SUNSET VILLAGE FILING NO. 4

CONSTRUCTION PLANS

EPC STORMWATER REVIEW COMMENTS
IN ORANGE BOXES WITH BLACK TEXT

MODIFIED FOR S.I.A. CD SET
RICHARD D. LYON, PE
ATWELL, LLC
DECEMBER, 2021
EPC PROJ.: CDR-21-008

POND SUMMARY TABLE								
DESIGN POINT	POND	TRIBUTARY AREA (AC)	WQCV WSEL	WQCV VOLUME (AC-FT)	EURV	EURV VOLUME (AC-FT)	Q ₅ (CFS)	Q ₁₀₀ (CFS)
B	A	22.23	5736.64	0.303	5737.70	0.480	27.8	57.4

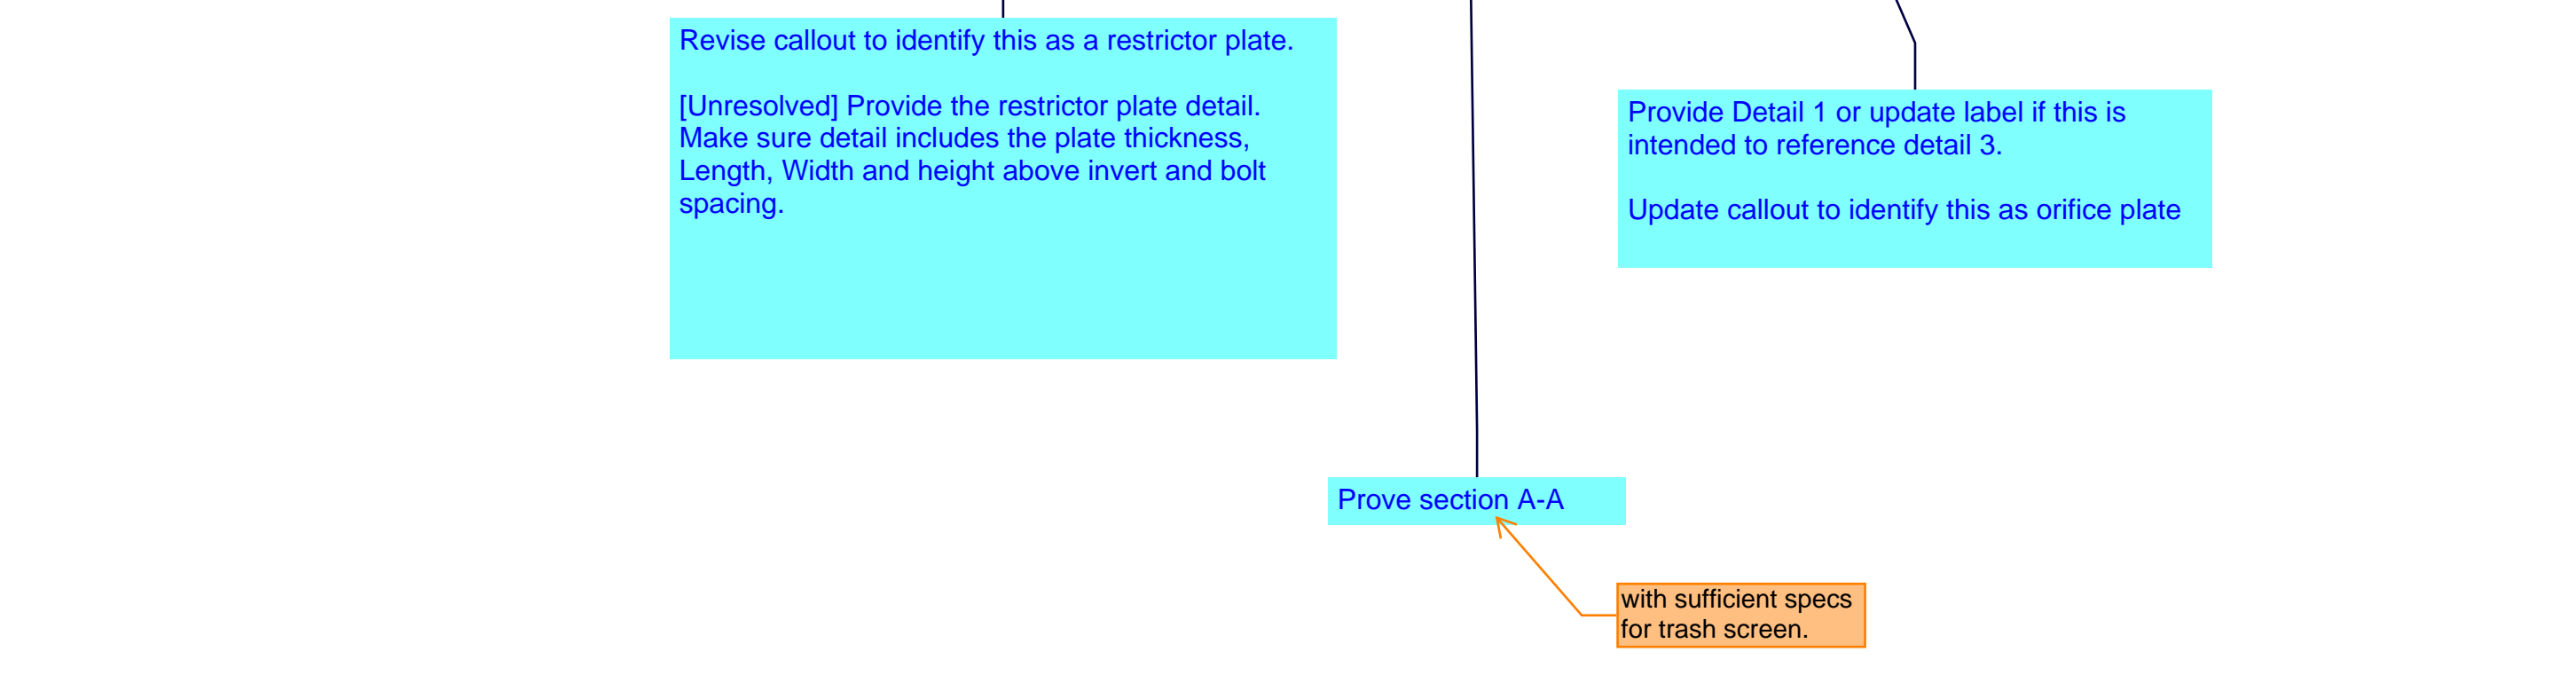
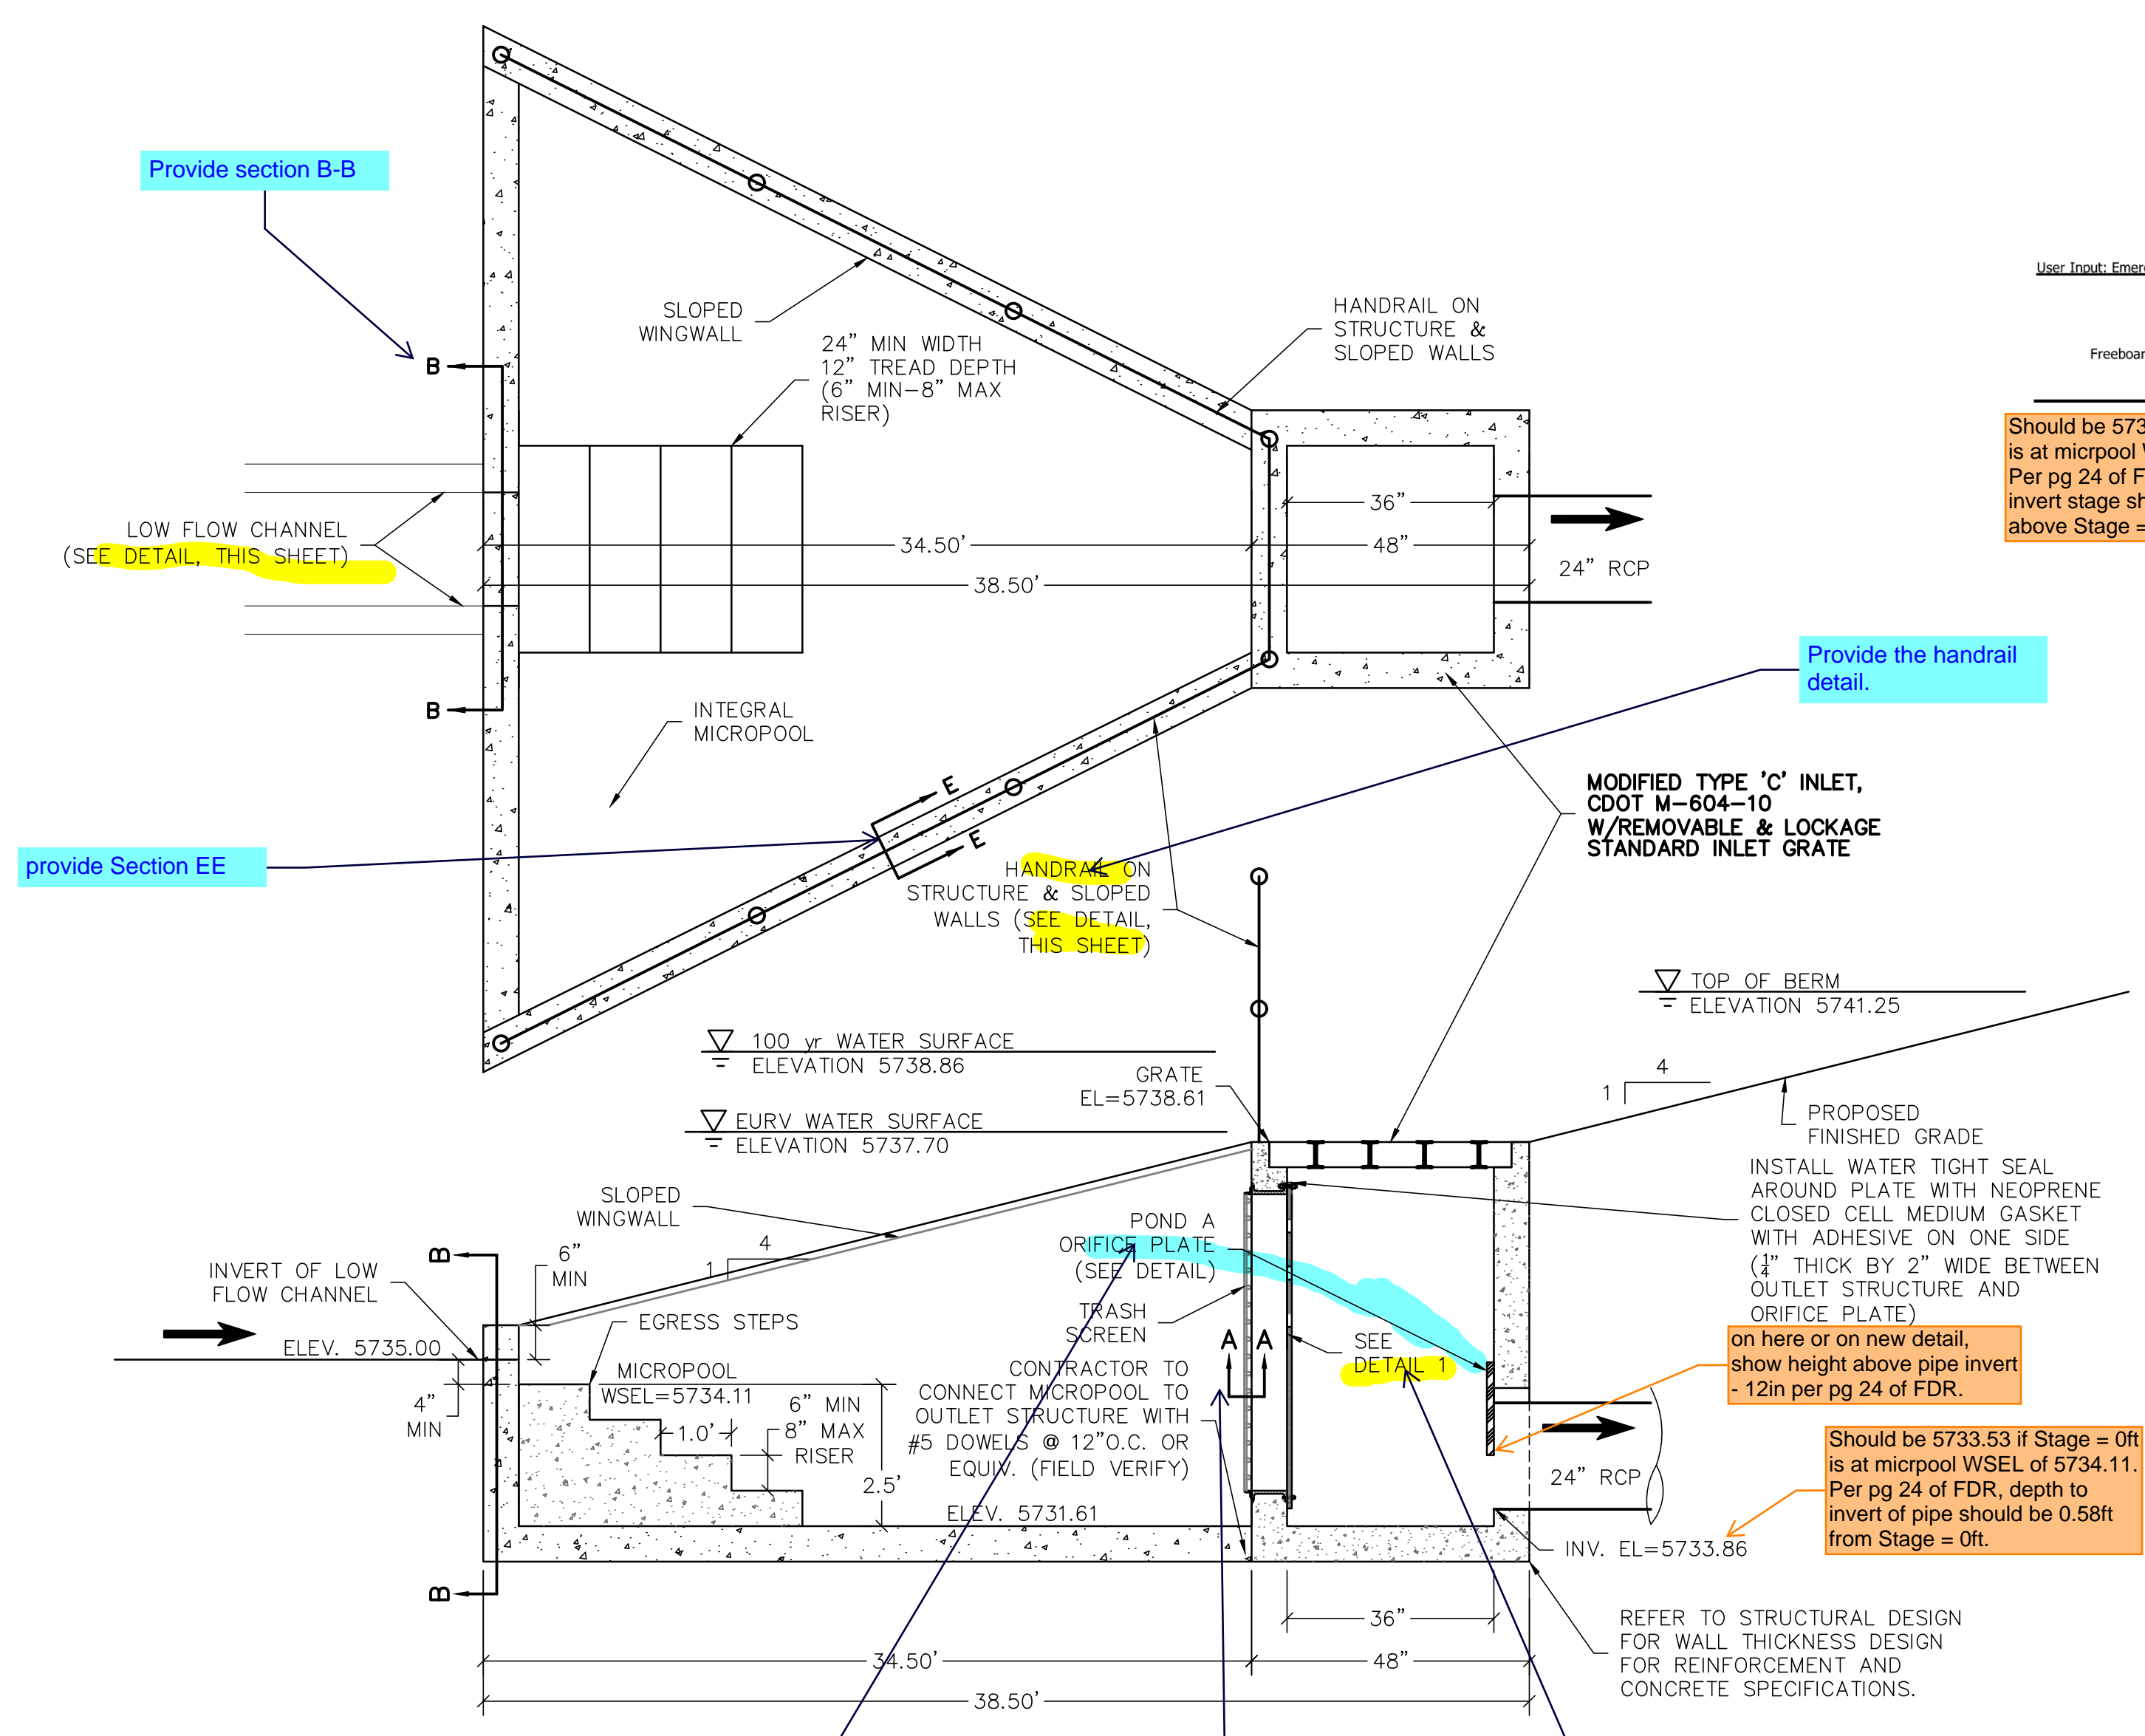
Should be 5739.51 if Stage = 0ft is at micropool WSEL of 5734.11. Per pg 24 of FDR, spillway invert stage should be 5.4ft above Stage = 0ft.

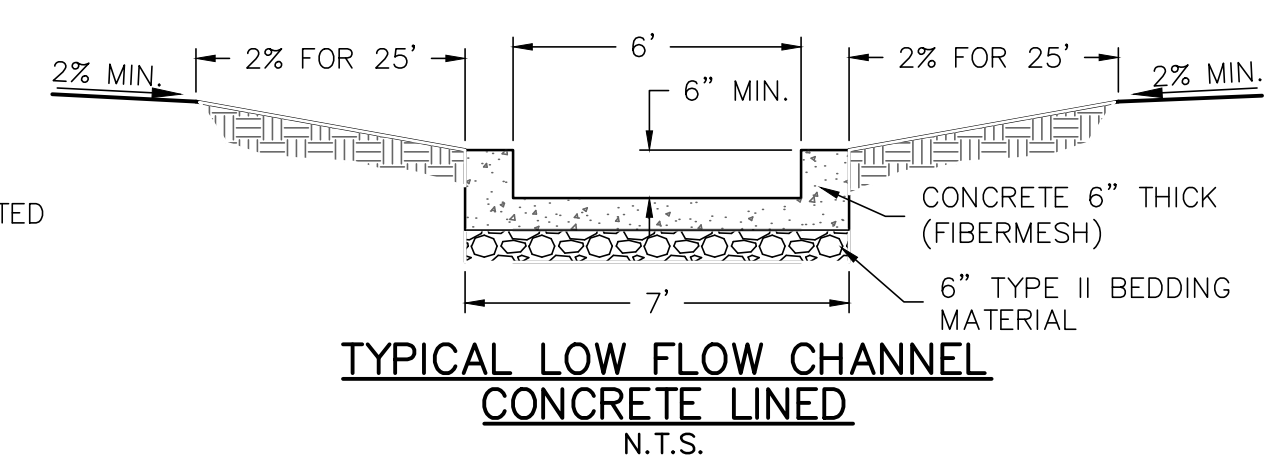
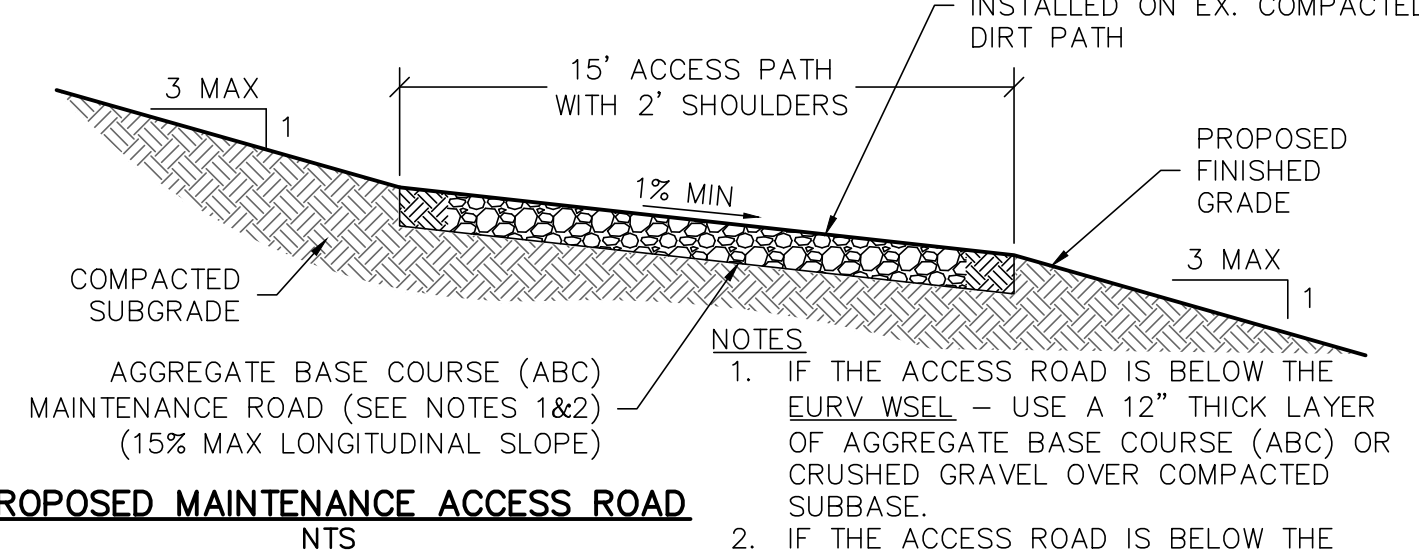
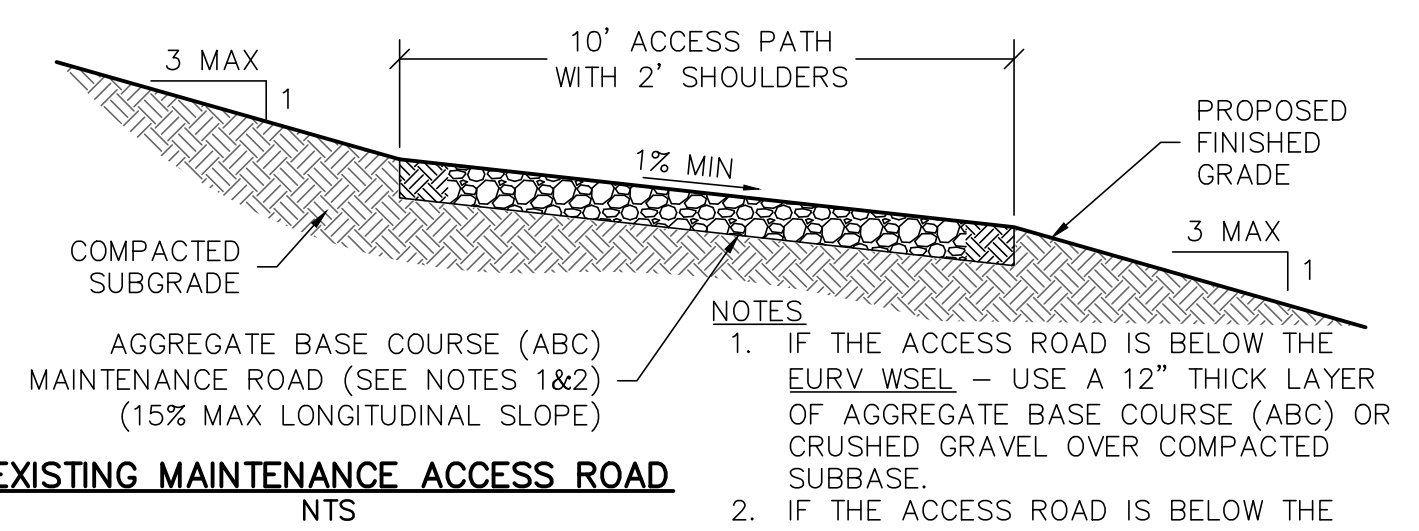
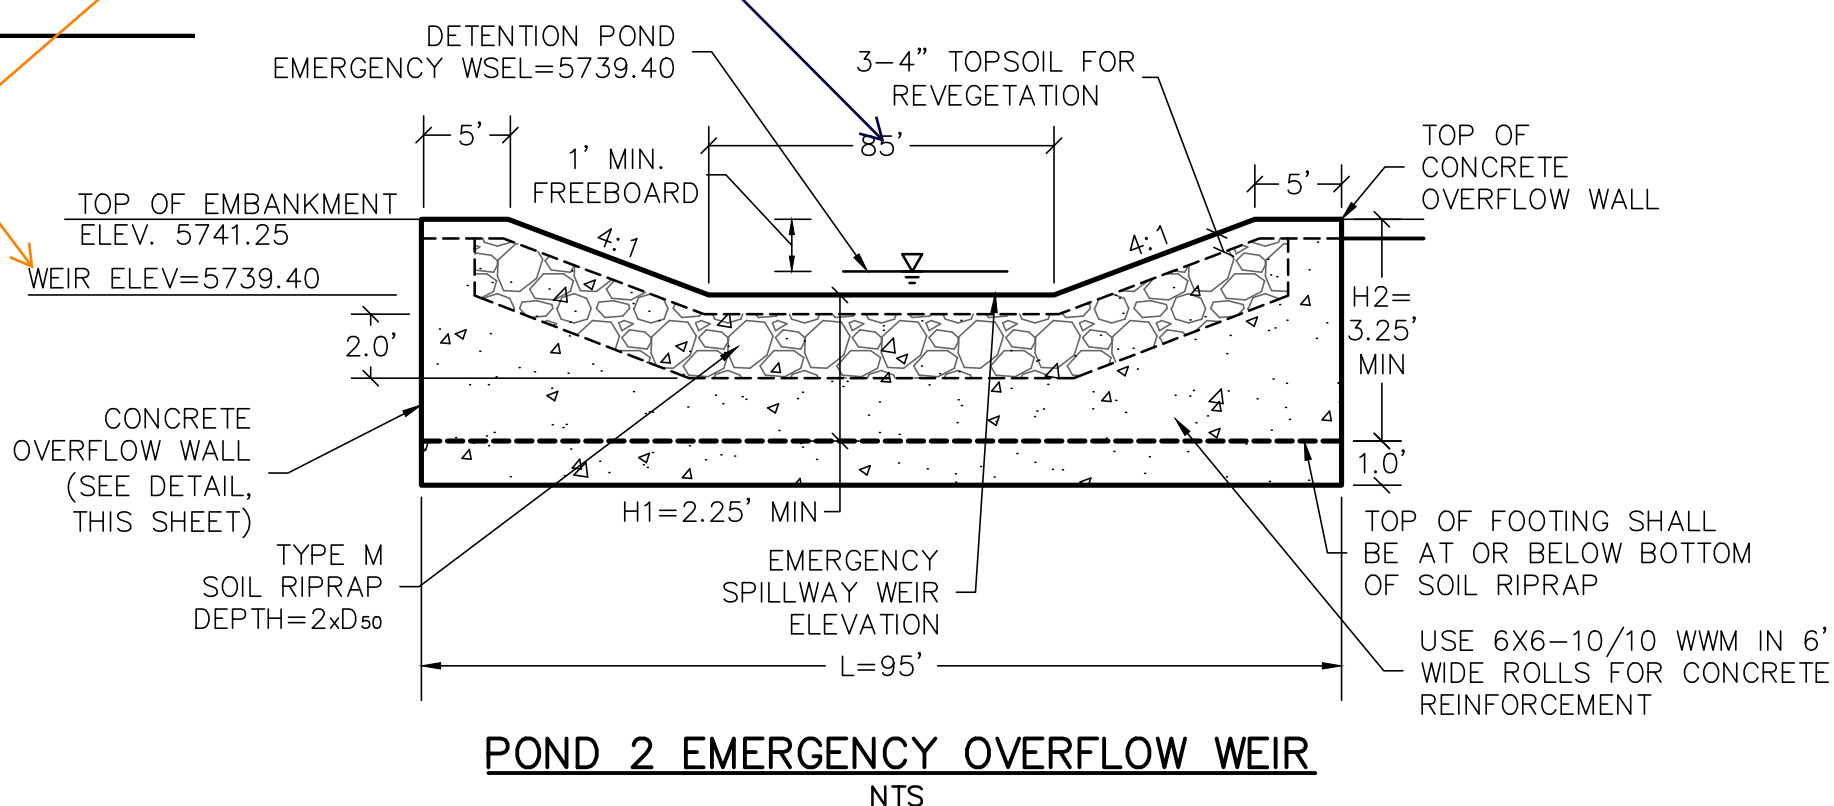
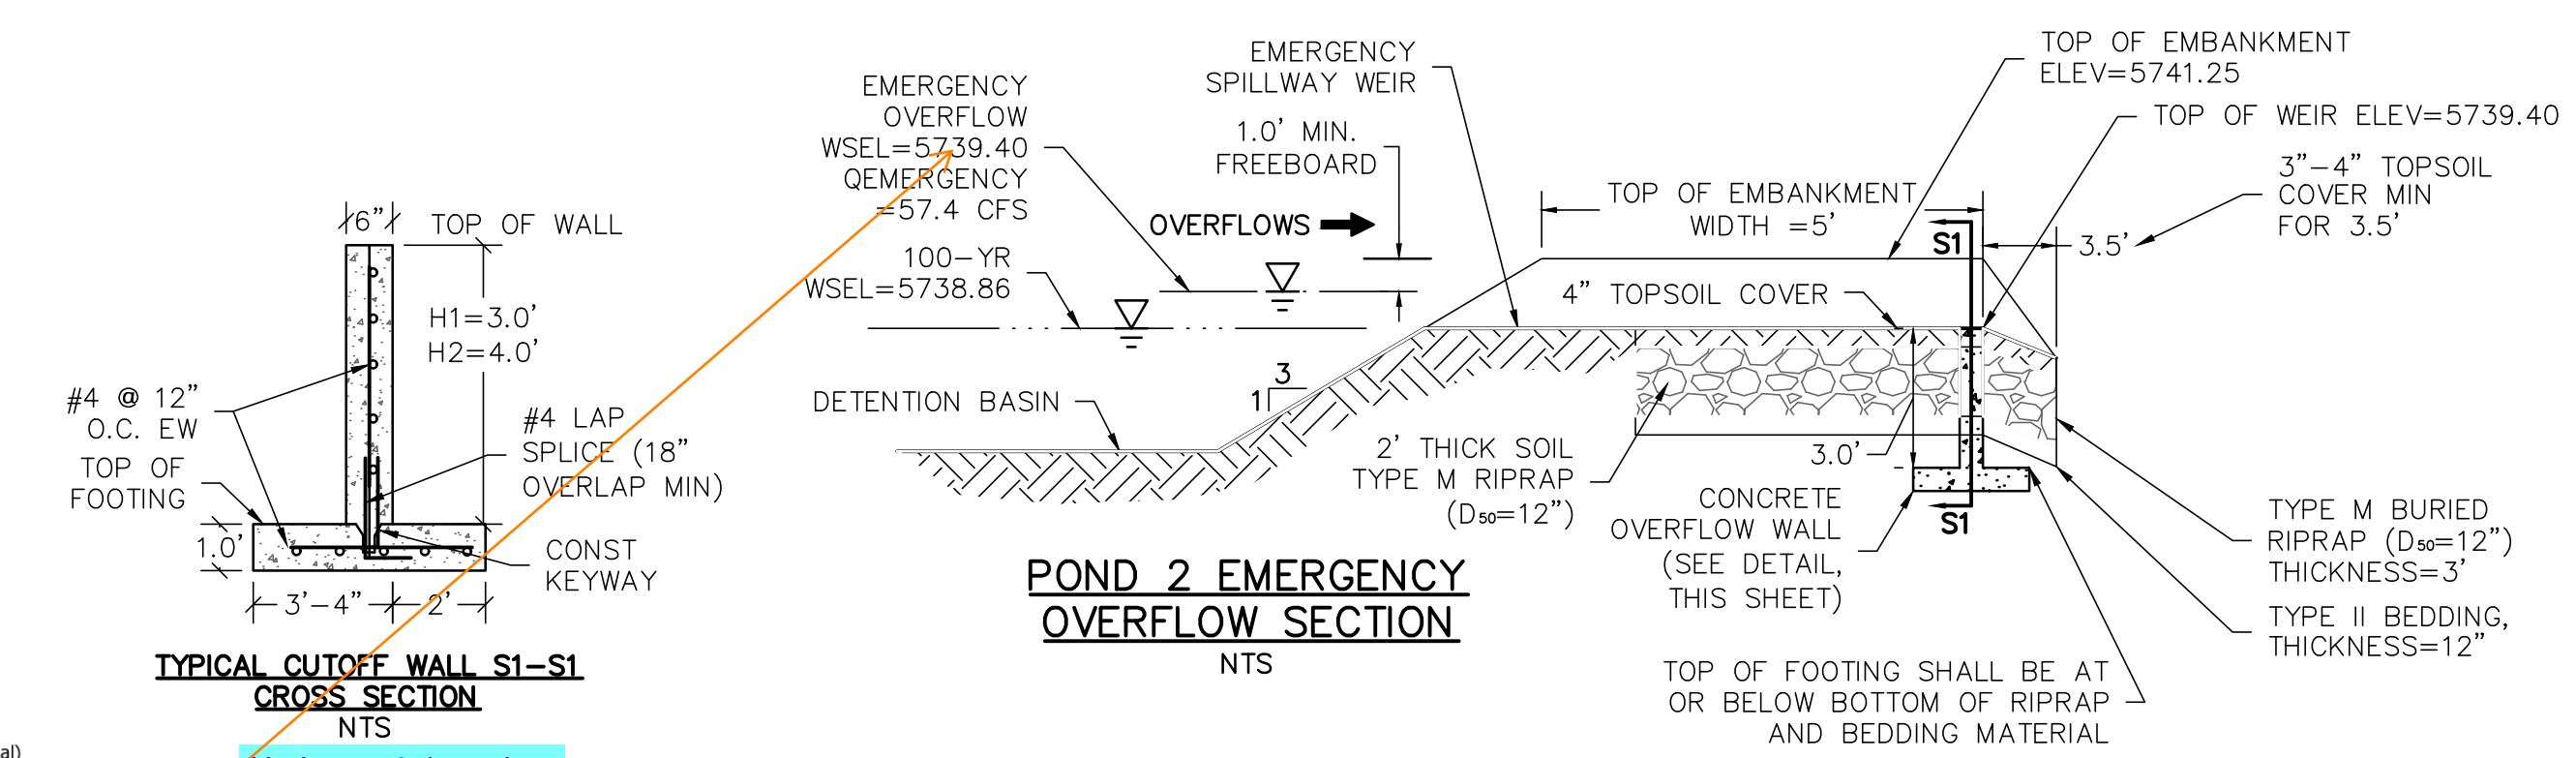
Should be 5733.53 if Stage = 0ft is at micropool WSEL of 5734.11. Per pg 24 of FDR, depth to invert of pipe should be 0.58ft from Stage = 0ft.

Revise callout to identify this as a restrictor plate.

[Unresolved] Provide the restrictor plate detail. Make sure detail includes the plate thickness, Length, Width and height above invert and bolt spacing.

Provide Detail 1 or update label if this is intended to reference detail 3.

Provide section A-A
